Horace Mann School New Const.

Change Order #37 = \$118,832

PROPOSAL REQUEST (PR)

INSTRUCTION BULLETIN: 07

**AFWALL® MILLENNIUM™ FloWise®
ELONGATED FLUSHOMETER TOILET**
VITREOUS CHINA LESS EVERCLEAN®

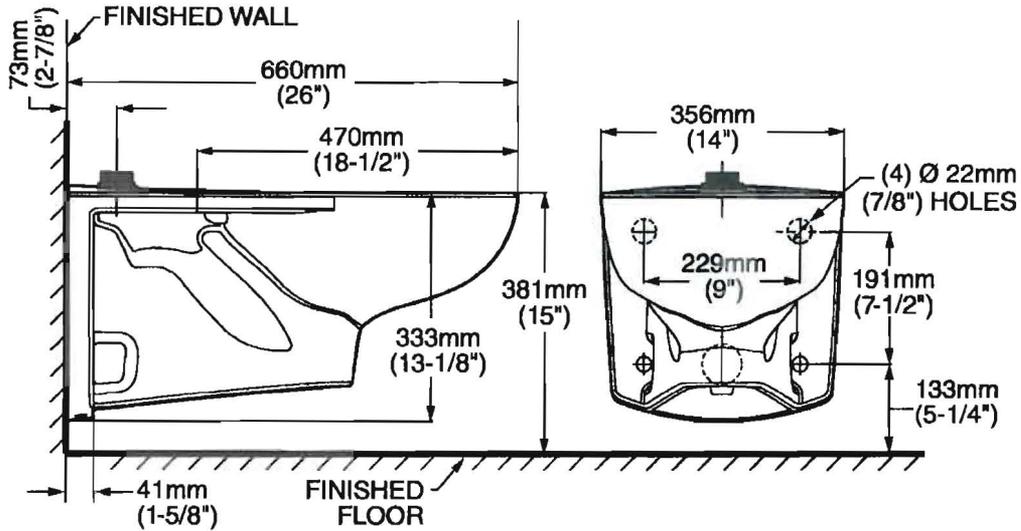
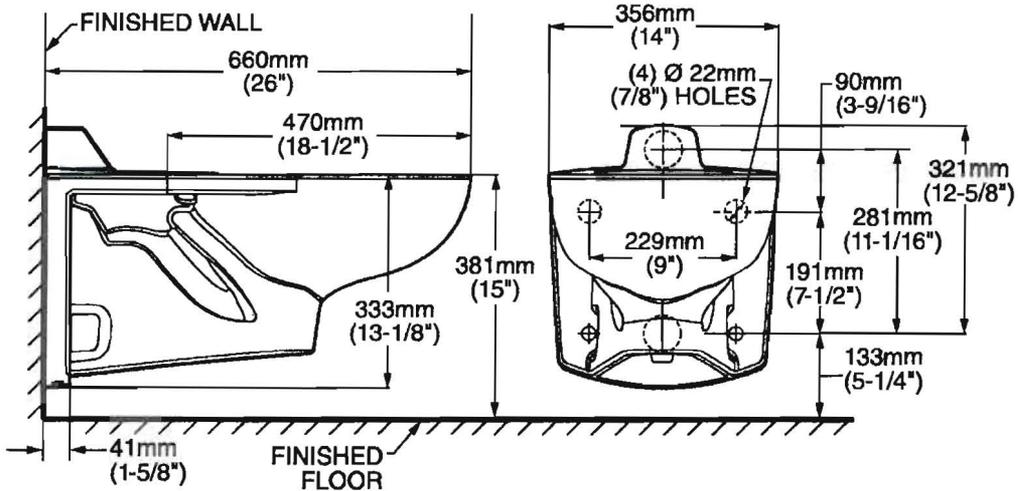
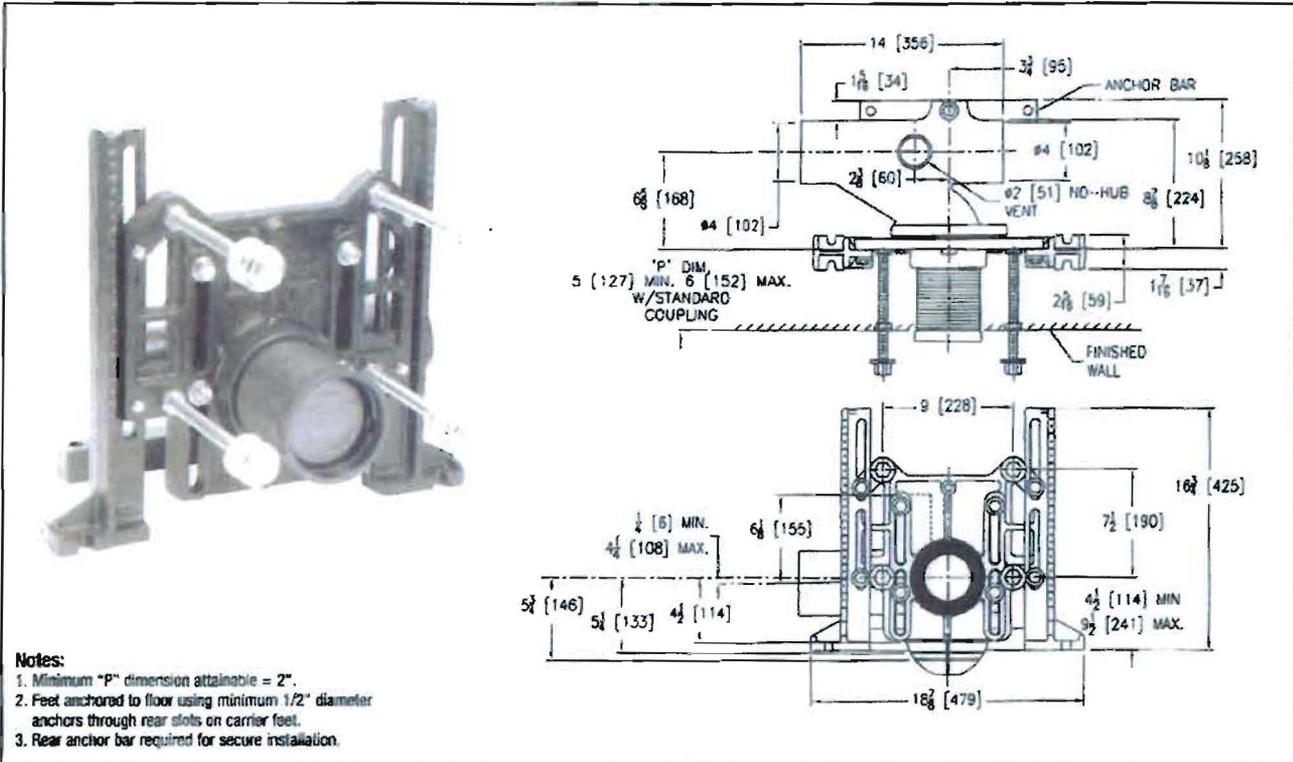
DESCRIPTION OF PROPOSED CHANGE: Schedule impact to critical path and pending additional costs associated with PLMG: Upgrade (1) additional water closet to a wall mounted unit in Girls RR # B255 due to conflict with steel beam support below slab deck (i.e. IB-10 & RFI 219 response)

In lieu of specified floor mounted water closets provide wall mounted water closets and carrier as per attached American Standard and Zurn catalog cut sheets. Note, no change to specified sensor activated flushometer.

HVAC CONDENSATE DRAIN & GAS PIPING DETAIL

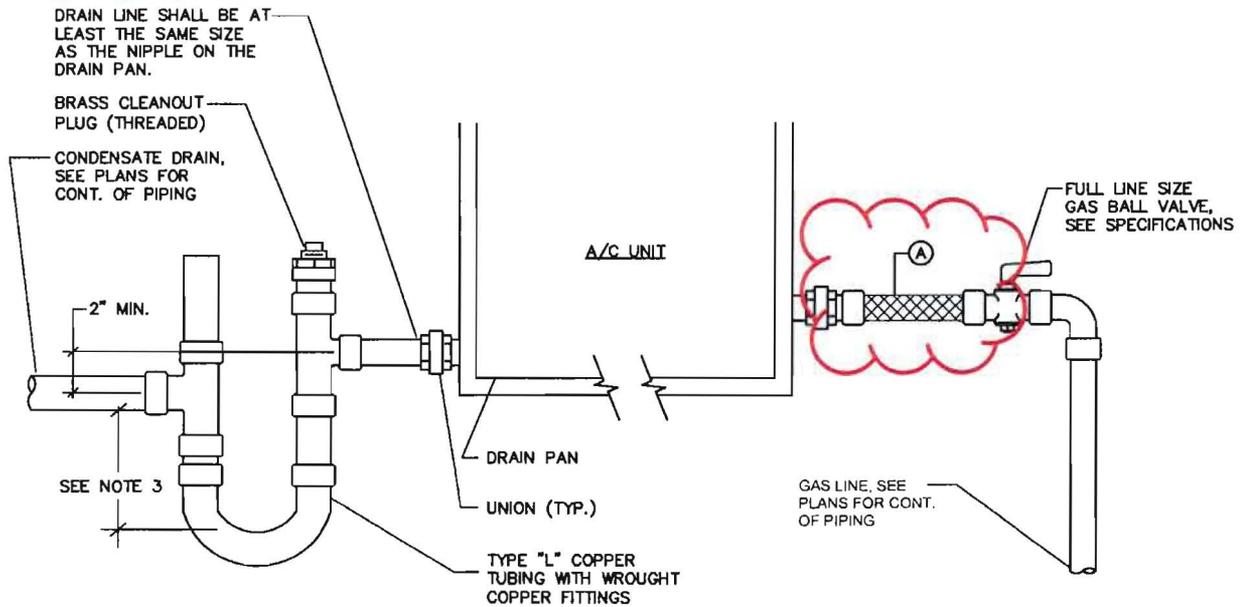
1. Provide and install PVC coated connection for gas and condensate drain connections to rooftop mechanical units.

There are no details in the plumbing drawings for the final gas and condensate hook-ups at the air conditioning units on the roofs. **Please provide direction.** Standard hard pipe connections will be utilized unless details are provided. Please clarify and advise.

Refer to the attached detail for gas and condensate drain connections to rooftop mechanical units.

(A) DORMONT GAS APPLIANCE CONNECTION WITH (PVC COATING)

**ENLARGED PLUMBING
PLANS**

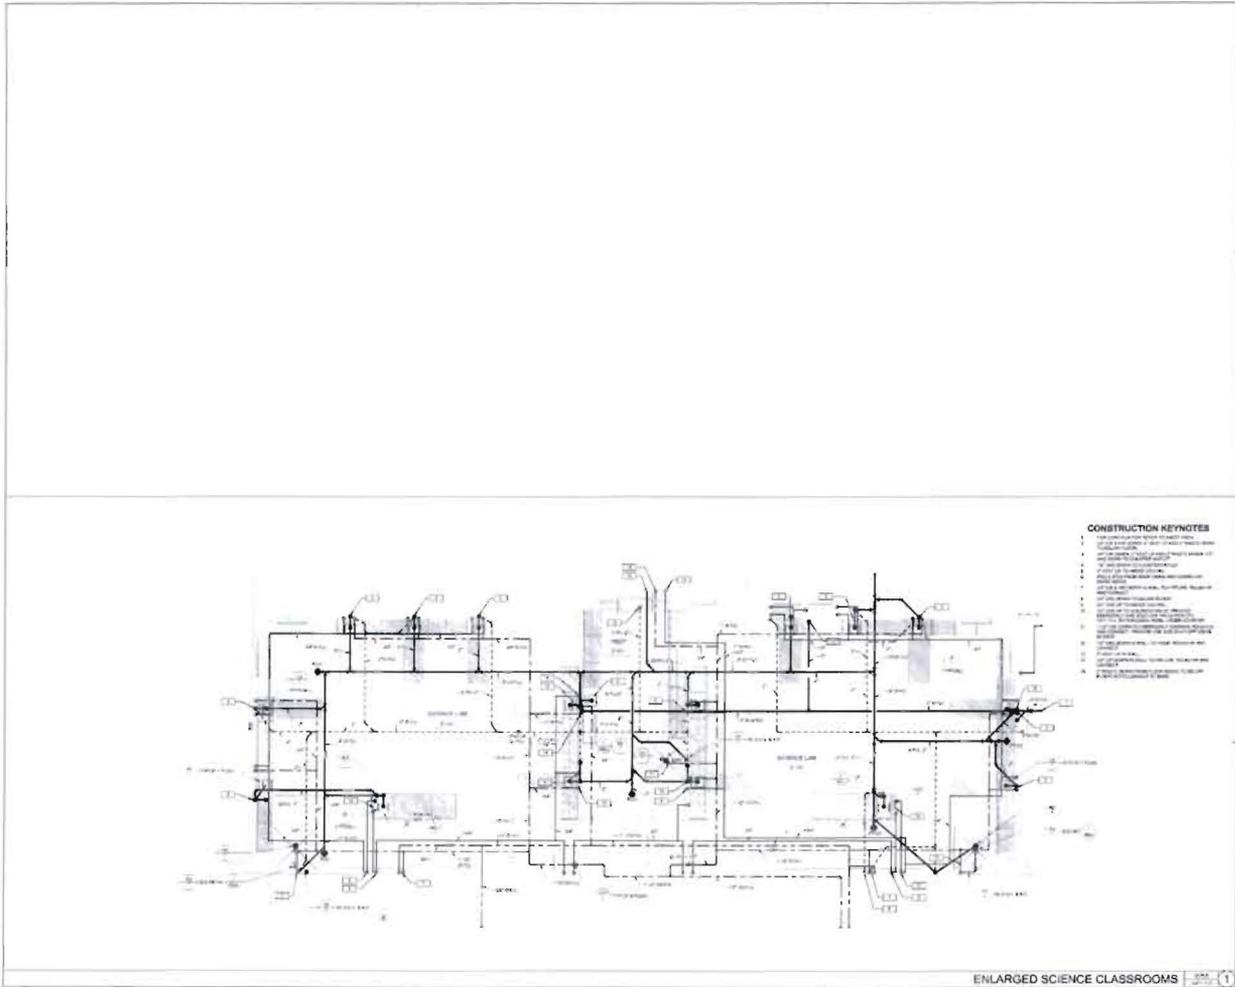
1. Add dedicated water lines from the main to the emergency showers so they are always active.

As designed, the emergency showers in the science labs are part of the water system that is controlled by the solenoid valves which means the showers would not work if the solenoid was not turned on. Per our discussion in the field, please confirm that you would like us to add dedicated water lines from the main to the emergency showers so they are always active. Advise.

-As directed by the Architect in RFI response #393, we are running dedicated water lines to the 3 emergency shower/eye wash stations so that the solenoid valves cannot shut the water off to them at any time. This work is already completed.

ITEM 5: RELOCATED HIGH VOLTAGE SWITCH

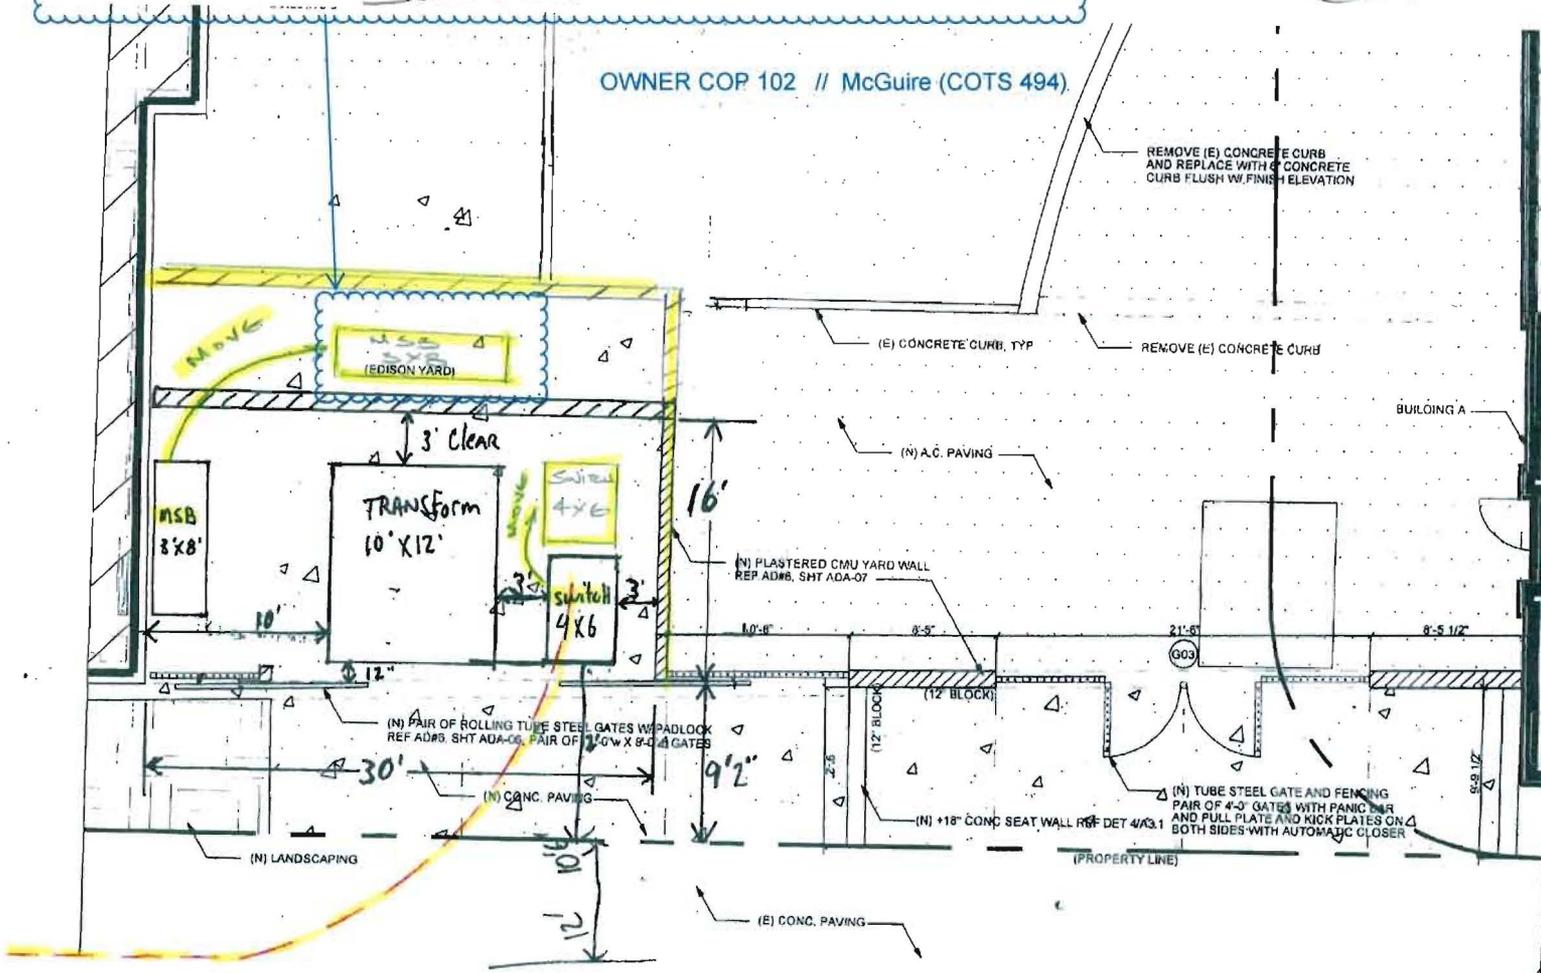
LONG RADIIUS
90° SWEEPS ADDED
